CONSULTANTS ADVICE

Project:	Carlingford West Public School	Ref No.:	F201502_02
Address:	59-73 Felton Road and part of 183 Pennant Hills Road, Carlingford	Date:	26 May 2021
		Issue:	Final Issue

RE: Preliminary Fire Safety Strategy

Figure 2-1: Proposed Spandrel Detail

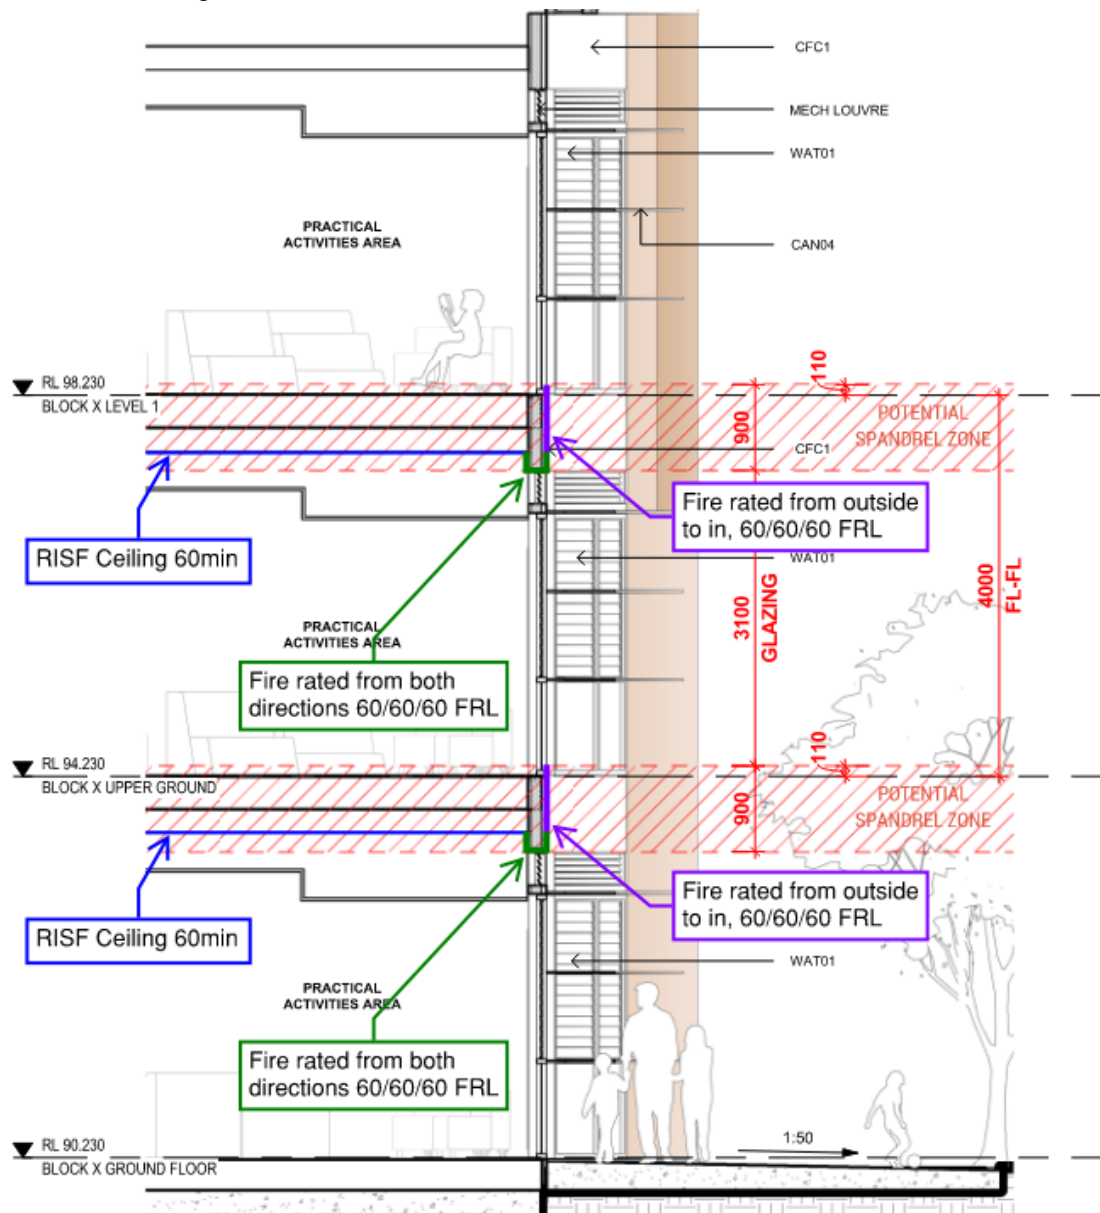
- Spandrel panels will not prescriptively achieve 60/60/60 in accordance with C2.6 of the BCA. Instead, the spandrels shall achieve the FRL in one direction (from outside in) unless they extend below the RISF ceiling. Additionally, the spandrels might not extend above the floor for the requisite 600 mm. The proposed detail is shown in Figure 2-1. The elements above the spandrel must be fixed closed toughened glazing or FC sheet to a height no less than 1 m above the floor.

Figure 3: Proposed onsite fire services infrastructure

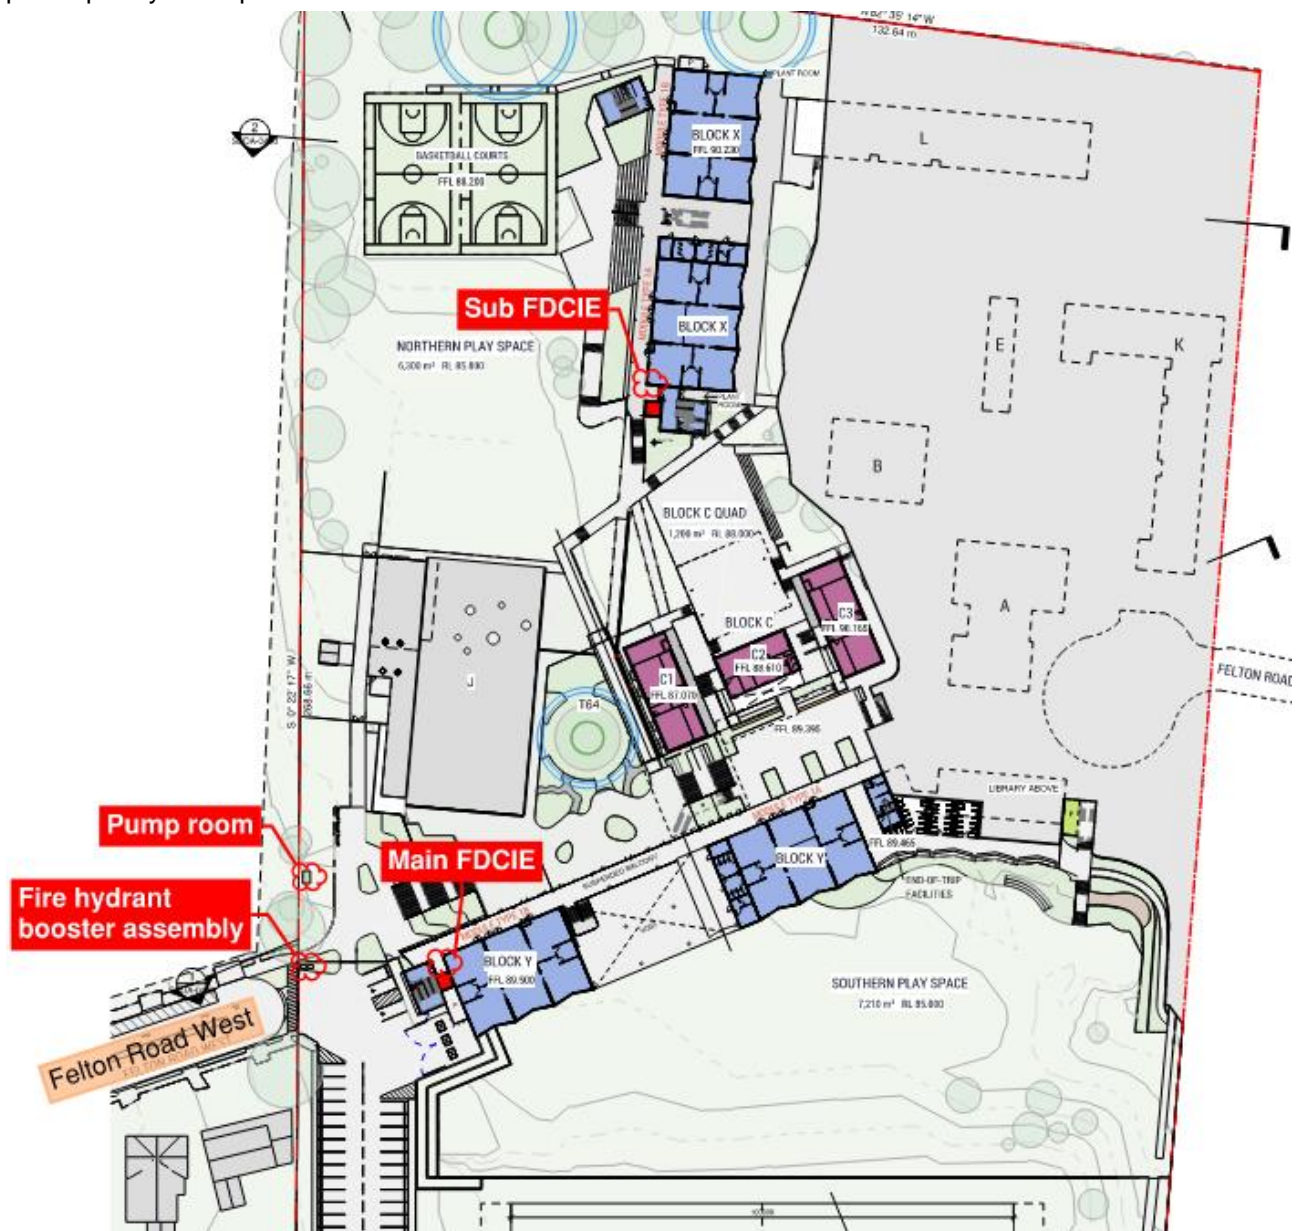
5	Fire Hydrant Booster Location <ul style="list-style-type: none"> To permit the location of the fire hydrant booster to not technically be within sight of each building entry on the site. 	<p>The hydrant booster is proposed at the bottom of the site, on Felton Road West (whereas the main entry is on Felton Rd East).</p> <p>Although this is not unreasonable, this will be subject to comment from FRNSW through the FEBQ process.</p> <p>It is noted that the main FDCIE shall be provided nearby at Building Y to improve communication between the FDCIE and the booster.</p>

- Fire hose reels – as per E1.4 and AS2441 noting that these are required only to areas not considered ‘classrooms and associated corridors’.
- Portable fire extinguishers – located as per AS2444 as the primary means of suppression.
- Fire Detection Control and Indicating Equipment (FDCIE) – located at Building Y, with the strobe to be visible upon approach from Felton Road West. An additional sub FDCIE can be provided at Building X.
- Air handling shutdown (where the mechanical system could unduly contribute to the spread of smoke between fire compartments).
- Smoke detection and alarm system – to AS1670.1:2018 Section 1-6 (i.e. enhanced from that required solely for air handling shutdown).
- Building occupant warning system.
